Proposal for Supplement 4 to the 03 series of amendments of UN Regulation No. 26 concerning the approval of vehicles with regard to their external projections

The text reproduced below was prepared by the expert from the European Association of Automotive Suppliers (CLEPA) taking into consideration the proposal submitted by France with documents ECE/TRANS/WP.29/GRSG/2018/17 and GRSG-11-08. The modifications to the existing text of the Regulation are marked in bold for new and strikethrough for deleted characters.

Figure 0 – Example of windscreen wiper parts"

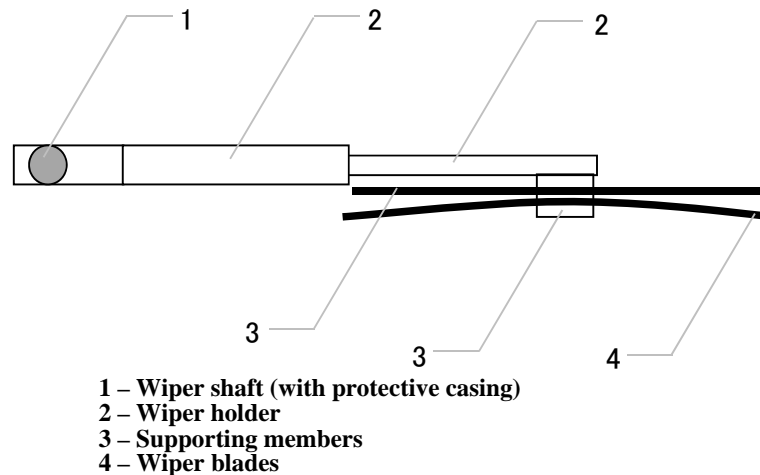
- 6.4.1. The windscreen wiper fittings shall be such that the wiper shaft (**number 1 in figure 0**) is **designed or** furnished with a protective casing which has a radius of curvature meeting the requirements of paragraph 5.4. above and an end surface area of not less than 150 mm². In the case of rounded covers, these shall have a minimum projected area of 150 mm² when measured not more than 6.5 mm from the point projecting furthest. These requirements shall also be met by rear window wipers and headlamp wipers.
- 6.4.2. Paragraph 5.4. shall not apply to the wiper blades (**number 4 in figure 0**) or to any supporting members (**numbers 2 and 3 in figure 0**). However, these units shall be so made as to have no sharp angles or pointed or cutting parts.

1. It is appropriate to make clear which parts of the windscreen wiper are subject to the requirements of para. 6.4.1. and which are only subject to the requirements of para. 6.4.2. intended for the supporting parts.
2. The proposal by France "de-fact" extends the requirements of para. 6.4.1. to the wiper holder, that being a supporting part, was never subject before to such stringent requirements. Before imposing new requirements a justification in terms of road safety improvements versus expanded costs, in relation to the wiper holder, shall be evaluated and agreed by GRSG.
